From: Paul McCarthy
Sent: 13/03/2025 5:13:12 PM
To: Council Northernbeaches Mailbox
Subject: TRIMMED: DA objection: DA2025/0077
Attachments: Objection to DA20250077- Freshwater.docx;

DA2025/0077

DA SUBMISSION – 10-28 LAWRENCE STREET, FRESHWATER

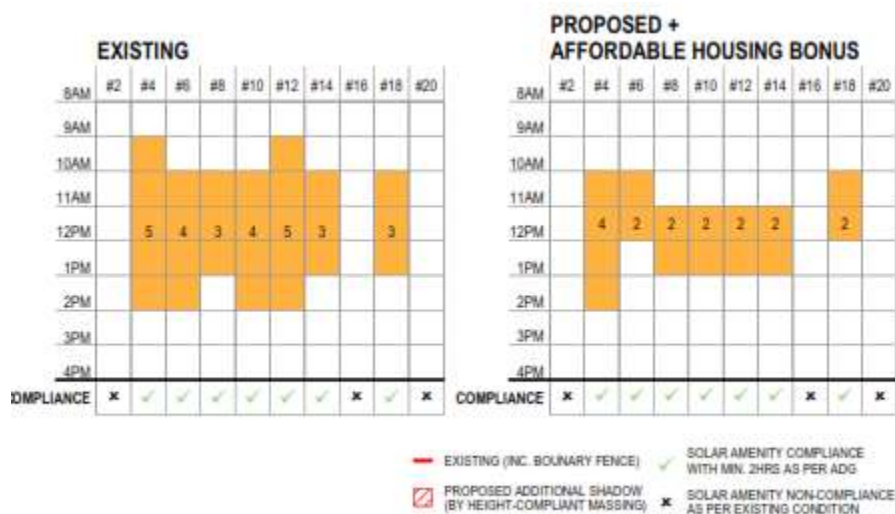
3. Lack of sufficient retail parking

The Warringah DCP requires 72 retail parking spaces.

The development provides 62 spaces, 10 spaces short.

The submitted traffic report provides no reasonable argument for the shortfall in parking provided. Parking in Freshwater is very difficult, and the lack of sufficient parking will place further stress on the availability of street parking which will impact on parking for local residents. Providing additional retail GFA without sufficient parking is contrary to the provisions of the DCP and will impact on public parking in the area.

- Reduction in building height to comply with the maximum height permitted
- Increase setbacks to the southern boundary to comply with ADG separation requirements
- Provide an additional 10 retail parking spaces
- Amend the building envelope to ensure all dwellings to the south retain a minimum of 3 hours solar access between 9am to 3pm as per Clause D6 of Warringah DCP
